July 1, 2004
9704-PFS-017

Enclosures: GT STRUDL Program Report Forms 2004.1 through 2004.9

GTSTRUDL Program Report Form

Incorrect Figure 3.14-3

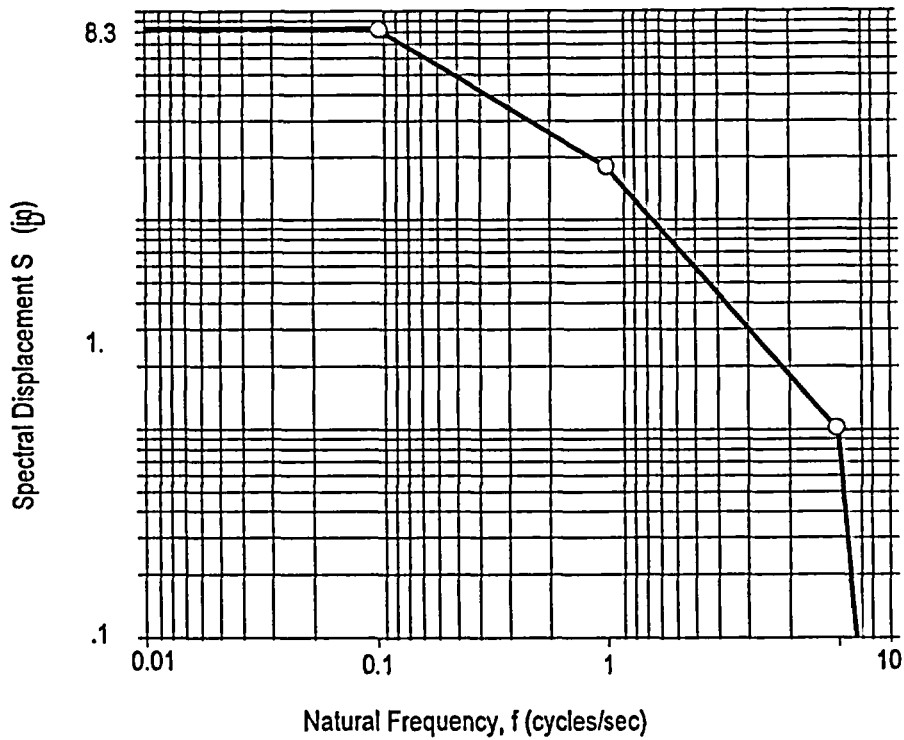
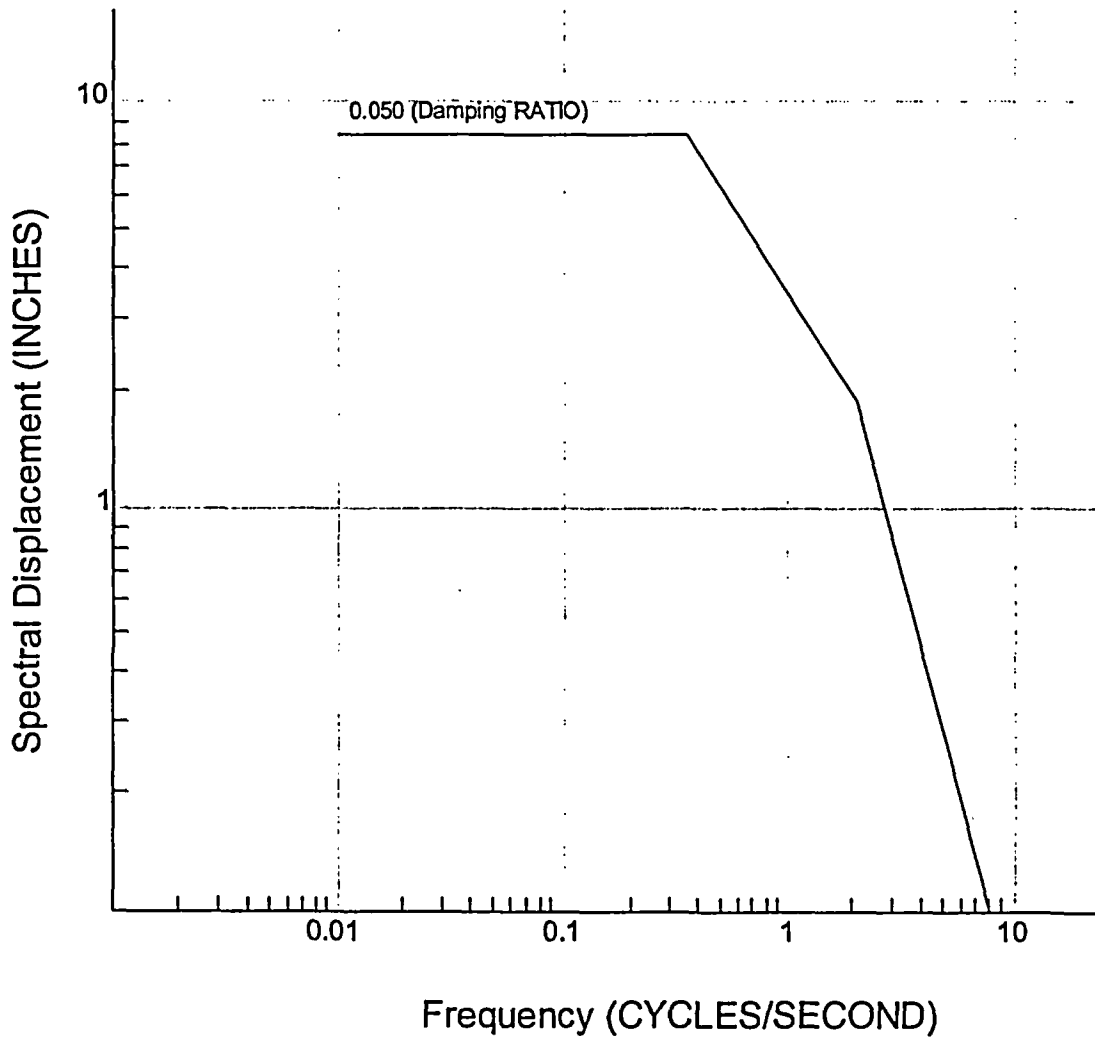
Figure 3.14-3, Section 3.14, GTSTRUDL Verification Manual, Volume 1, depicting an X-Y plot of response spectrum file EQUAKE, is incorrect. The incorrect figure is shown below, followed by a correct figure:

Correct Figure 3.14-3
